RESPONSE LETTER NO. 2 TO REQUEST FOR INFORMATION

Project Title: **Roadway Improvements to NE 151 Street from East of Railroad Tracks to Bay Vista Boulevard**
Project No.: **20210092 (Capital)**

"Typical Section of the project along Sole Mia Way"

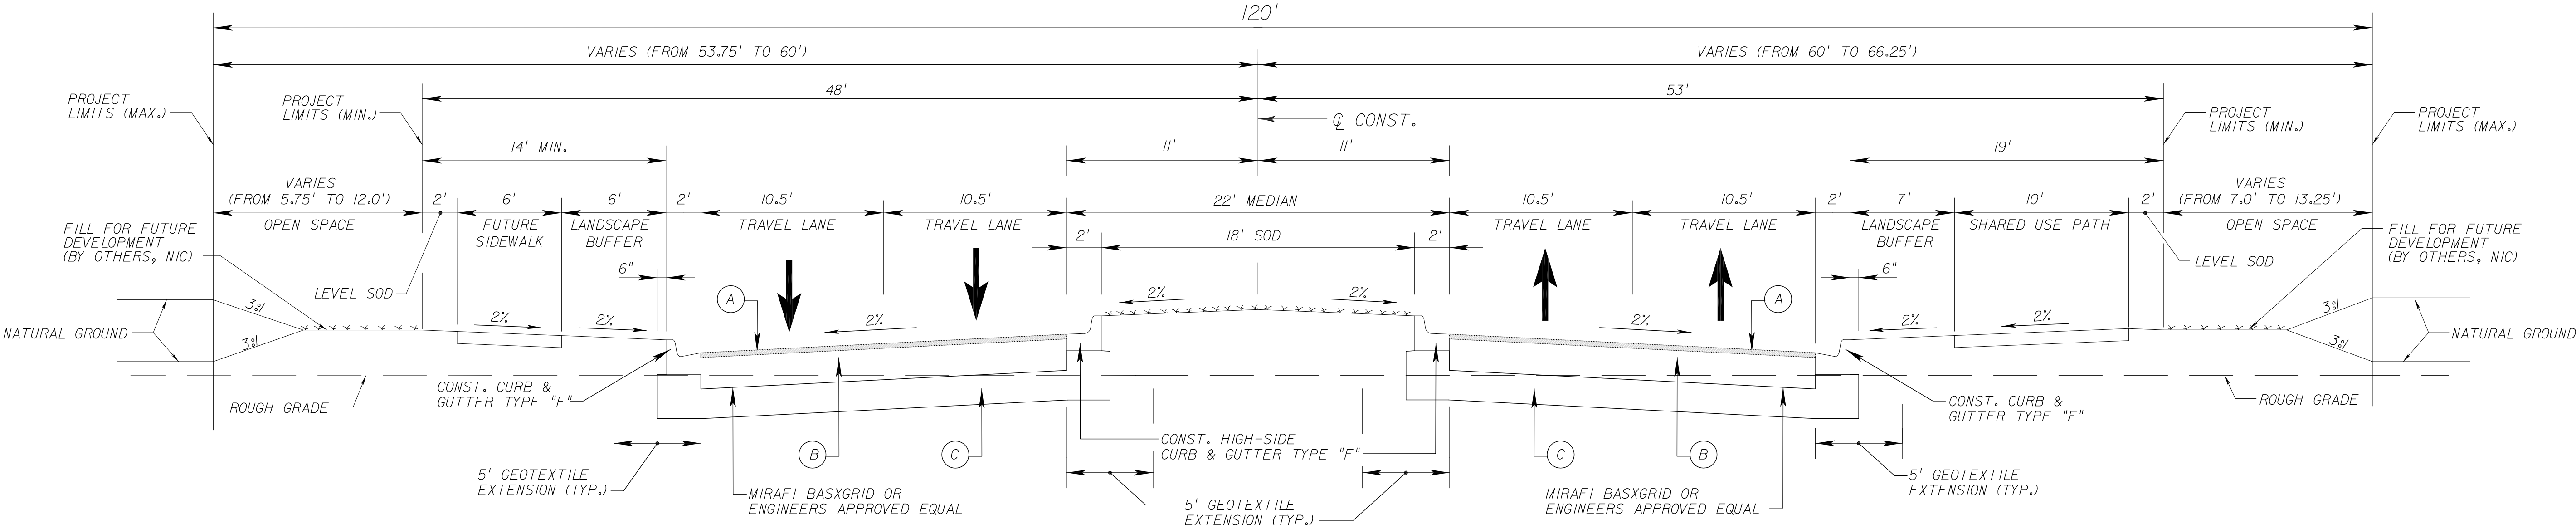
QUESTION: 7) Plan Sheet 9 of 138 – “CONTRACTOR SHALL REPLACE ANY EXISTING GEOTEXTILE BETWEEN THE SUBGRADE AND THE LIMEROCK THAT IS DAMAGED DURING CONSTRUCTION. CONTRACTOR TO VERIFY EXACT LOCATIONS DURING

CONSTRUCTION.” Is this applicable to this project and at which locations?

RESPONSE: 7) Yes, it is applicable to this project. The geotextile was placed in the vicinity of Sole Mia Way as part of the development built in the area. Please see attached Typical Section of the project along Sole Mia Way (previously Sole Mia boulevard) for reference purposes.
